SUPPLEMENTARY BUSINESS PAPER

LOCAL PLANNING PANEL MEETING

ITEM 1 LPP11/25 - DA/85/2025 - Demolition of Structures and Construction of a Dwelling House - 316 & 318 Malton Road, North Epping

Additional information with NO CHANGE to Recommendation
--

SITE PHOTO OF 318 MALTON RD EXISTING CARPORT LATTICE SCREEN

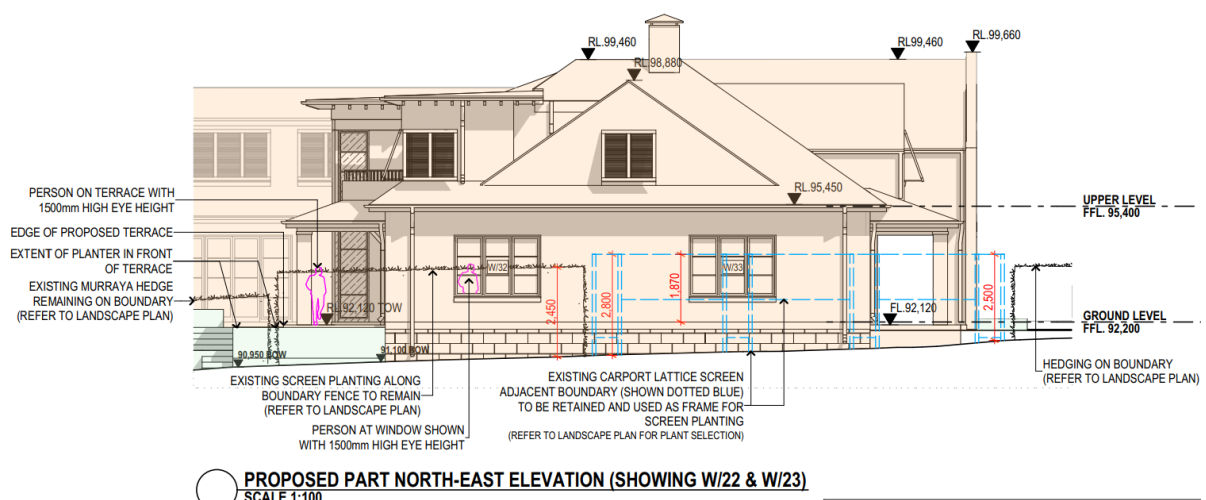
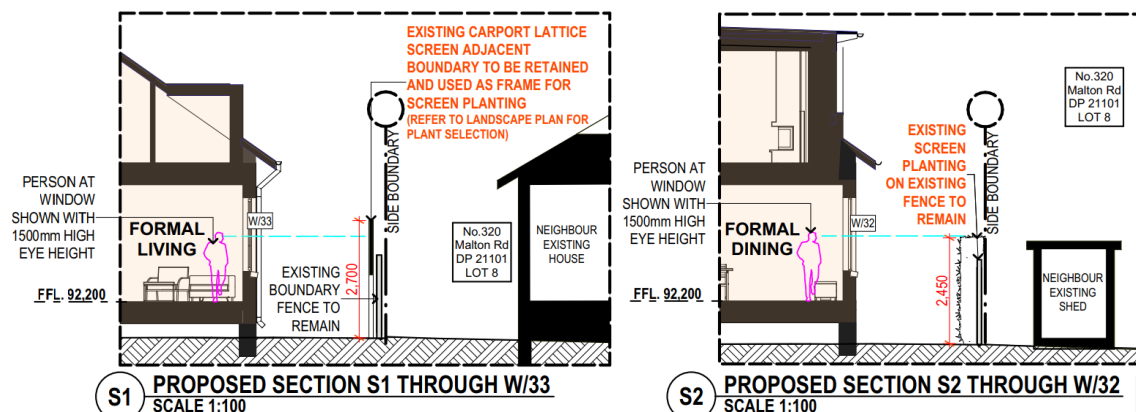
The applicant has submitted details demonstrating that the existing lattice screening atop the fence adjoining No. 320 Malton Road would remain and not be removed as part of the demolition of the carport structure in this location. The applicant has requested that this lattice as well as existing additional vegetation screening be considered in lieu of additional privacy measures along the north-eastern elevation for the formal dining, formal living room and verandah.

This is supplemented by a sight line diagram detailing that the existing lattice screening and existing screen planting provides appropriate visual screening between the site and adjoining property known as No. 320 Malton Road as follows:

No concerns are raised by Council with the recommendation submitted by the applicant and therefore condition No. 2 subclause 3 is amended to read:

3. To comply with the HDCP privacy requirements, the approved plans are to be amended as follows:
 - a. The existing carport lattice screen adjacent the north-eastern boundary on the side fence is to be retained at a minimum height of 2.45m and be used as a frame for screen planting.

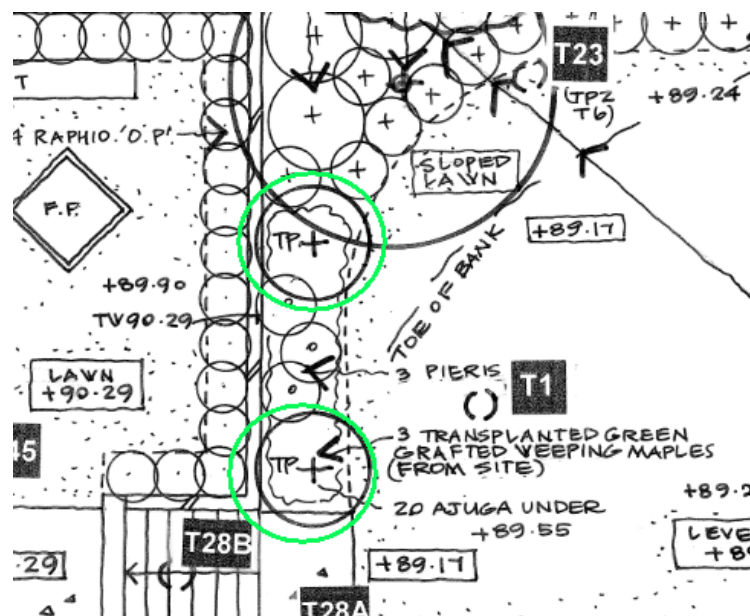
The applicant raised concerns regarding the inconsistency of the requirements of condition No. 62.1.a and 62.1.b to locate the trees 4m or greater from the foundation walls of the approved development and the location of the transplanted Trees 25A and 25B on Plan No. LP01-B Landscape Plan Issue B, prepared by Selena Hannan Landscape Design dated 15 April 2025 as shown in green on the below extract.

No concerns are raised by Council regarding the proposed amendment to the wording of condition No. 62 subclause 1 and 3 to provide clarity and therefore condition No. 62 is amended to read:

1. The trees approved for removal under this consent, being trees numbered 1, 3, 4, 8, 22, 23, 27, 28A, 28B, 29, 30, 31, 32, 33, 35, 36, 40, 41, 42, 43, 44, 45, 46, 47 and 48 must be offset through replacement planting of a minimum of 10 trees.
 - a. Trees numbered 11, 25a and 25b are to be transplanted as per the approved Arboricultural Impact Assessment prepared by Selena Hannan Consulting Arborist dated 3 January 2025 and under the supervision of the project arborist.
 - b. The location of transplanted tree Nos. 25a and 25b must be in accordance with the approved Plan No. LP01-B Landscape Plan Issue B, prepared by Selena Hannan Landscape Design dated 15 April 2025.

- c. *The location of the transplanted tree No. 11 must be in either the front or rear setback and planted 4 metres or greater from the foundation walls of the approved development.*
